Re: Indian Point Units 2 & 3
Docket Nos. 50-247 & 50-286

NL-07-138

SUBJECT: **Reply to Request for Additional Information
Regarding License Renewal Application**

**ENTERGY NUCLEAR OPERATIONS, INC
INDIAN POINT NUCLEAR GENERATING UNIT NOS. 2 and 3
DOCKETs 50-247 and 50-286**

Figure 2.5-2
IP2 Offsite Power Scoping Diagram

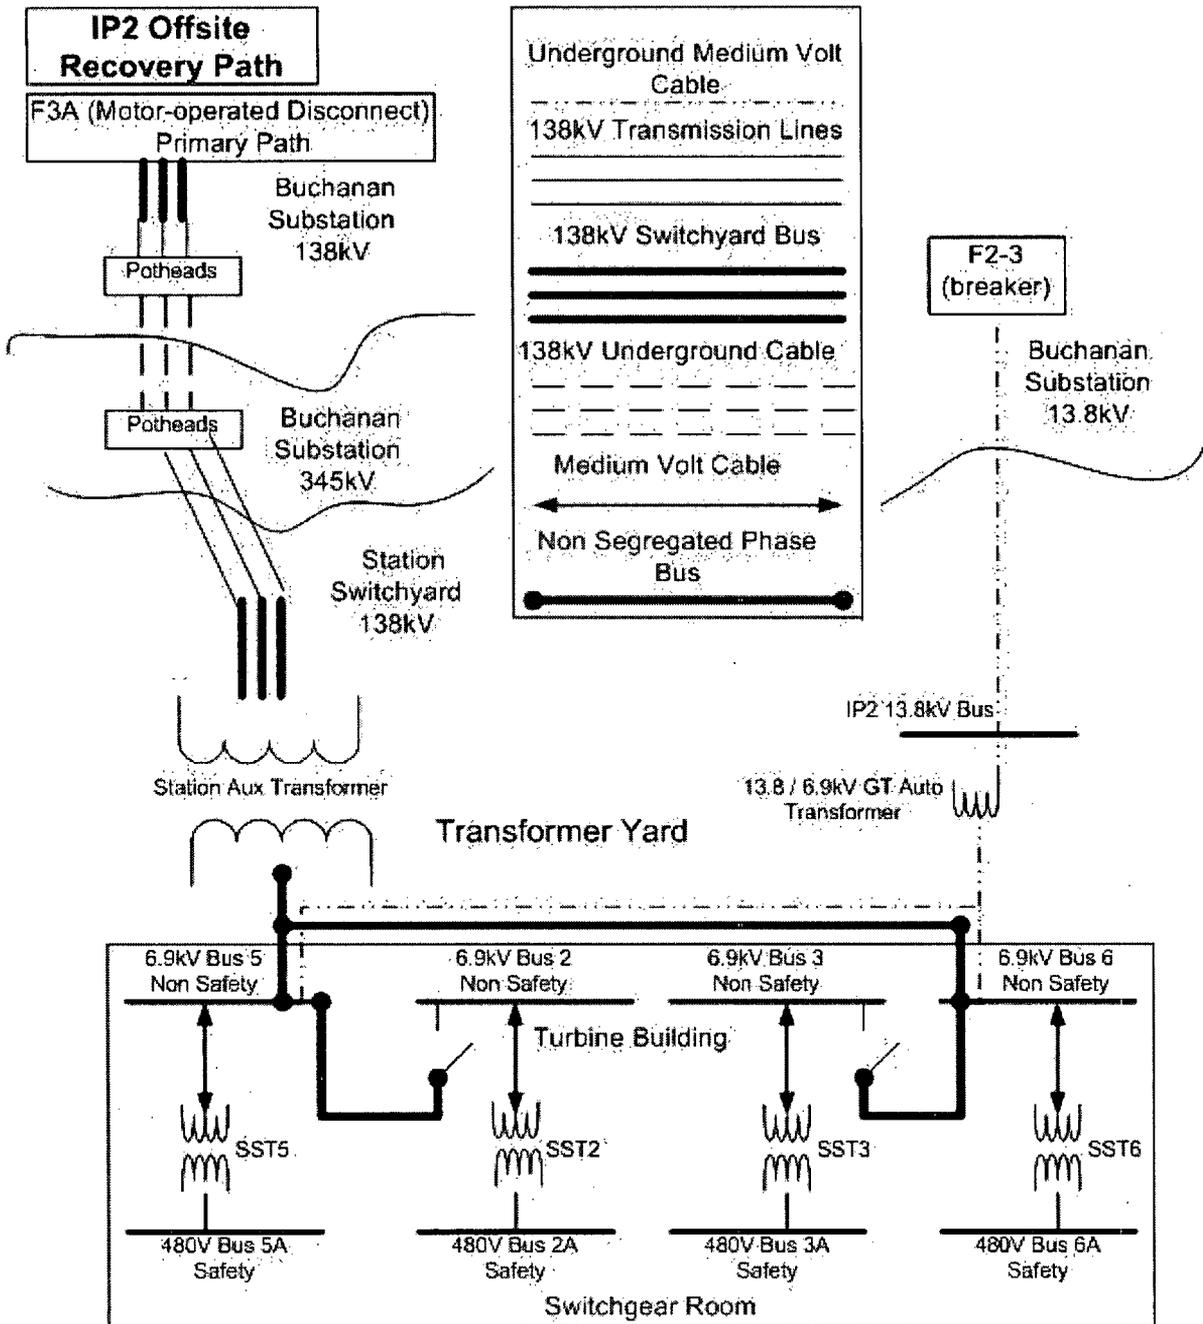
LRA Figure 2.5-2 showed only the primary offsite power source or the 6.9kV source from the 138kV/6.9kV station auxiliary transformer, which is connected to the Buchanan substation through the Con Edison 138kV feeder. Figure 2.5-2 is revised as shown in this response to add the secondary offsite power feeder from the 13.8 kV Buchanan substation via the GT autotransformer.

As shown in the revised LRA Figure 2.5-2, the 6.9 kV buses receive power from the two independent sources of offsite power via the 138 kV / 6.9 kV station auxiliary transformer or the 13.8 kV / 6.9 kV GT autotransformer. The station auxiliary transformer is connected to the 138 kV Buchanan substation, the primary offsite power source, via switchyard bus, overhead transmission conductors, and underground transmission conductors through motor-operated disconnect F3A, which is located at the Buchanan substation. The GT autotransformer is connected to the 13.8 kV Buchanan substation, the secondary offsite power source, via underground medium voltage cable through breaker F2-3, which is located at the Buchanan substation.

**Figure 2.5-3
 IP3 Offsite Power Scoping Diagram**

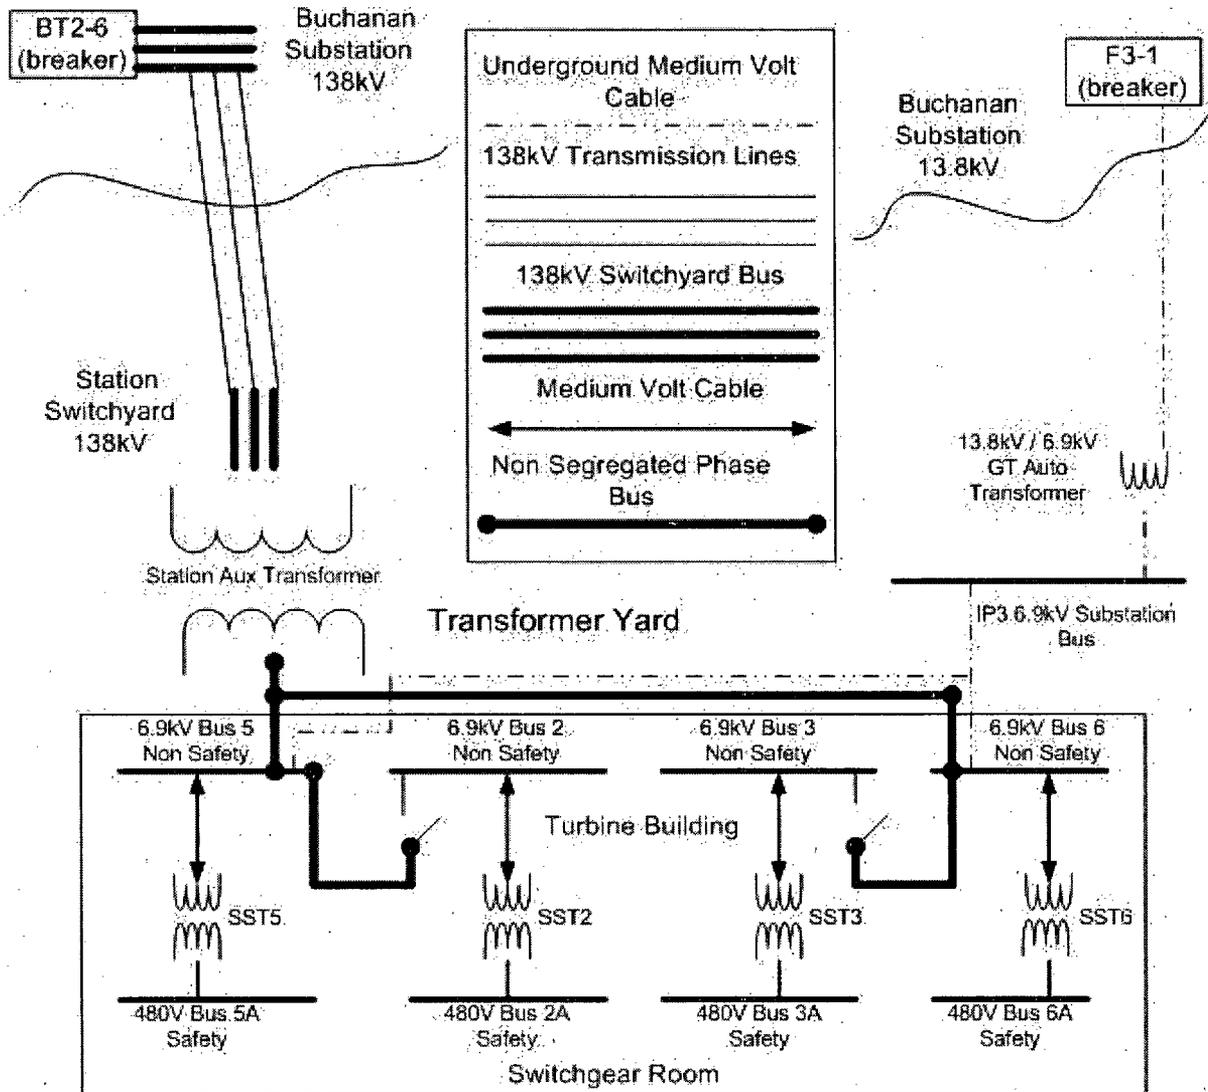
LRA Figure 2.5-3 showed only the primary offsite power source or the 6.9kV source from the

138kV/6.9kV station auxiliary transformer, which is connected to the Buchanan substation through the Con Edison 138kV feeder.. Figure 2.5-3 is revised as shown in this response to add the secondary offsite power feeder from the 13.8 kV Buchanan substation via the GT autotransformer.

As shown in the revised LRA Figure 2.5-3, the 6.9 kV buses receive power from the two independent sources of offsite power via the 138 kV / 6.9 kV station auxiliary transformer or the 13.8 kV / 6.9 kV GT autotransformer. The station auxiliary transformer is connected to the 138 kV Buchanan substation, the primary offsite power source, via switchyard bus and overhead transmission conductors through breaker BT2-6, which is located at the Buchanan substation. The GT autotransformer is connected to the 13.8 kV Buchanan substation, the secondary offsite power source, via underground medium voltage cable through breaker F3-1, which is located at the Buchanan substation.
